**Question 2: Summary Consideration:** Prior to the issuance of Order 743a, the SDT reviewed all of the provided material and used this material and the examples supplied in its consideration of the revised definition of the Bulk Electric System (BES). The goal of the SDT is to provide a bright-line definition of BES which adheres to the guidelines and directives in Order 743. This bright-line definition contains certain inclusions and exclusions for specific equipment and configurations. The SDT believes that this definition now answers many of the questions raised by industry and encompasses most of the examples provided. However, no bright-line definition will be able to capture all of the concerns or situations. Accordingly, and consistent with Order 743, another aspect of this project is to establish an exception process with criteria based on reliability principles for the Interconnected BES that will be incorporated in NERC’s Rules of Procedure (ROP) that will allow a process for the inclusion or exclusion of a particular BES Element from the definition. This ROP work effort will be done by a separate team but the DBESSDT will be in close coordination with that team.

2. If

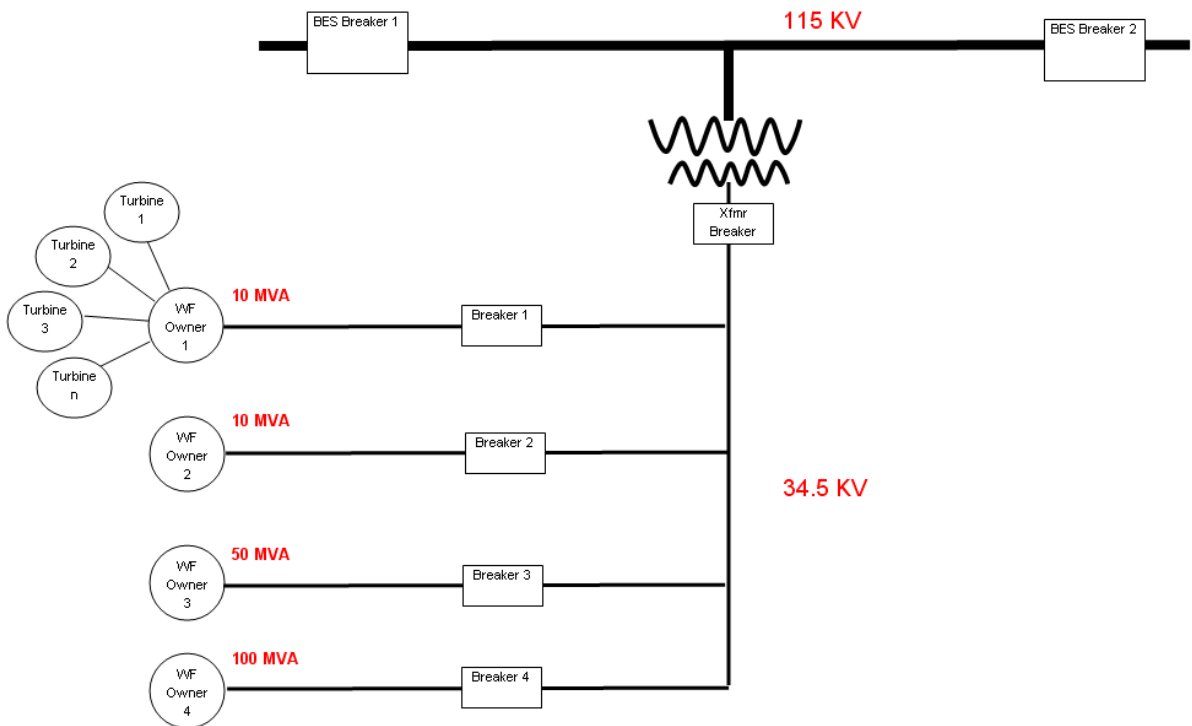
Comments relative to the proposed inclusion(s): The scenario below should be considered and worked through as part of the development of the definition and exemptions. As stated in questions 2, 3, 8 of the BES definition comment questionnaire it is unclear as to how treatment of facilities would occur, especially if there are multiple/separate owners of each wind farm, even though they aggregate to a common bus that connects to the transmission system. Treatment of the bus and breakers between each wind farm and the transformer also needs to be contemplated and addressed in the definition or exclusion process.
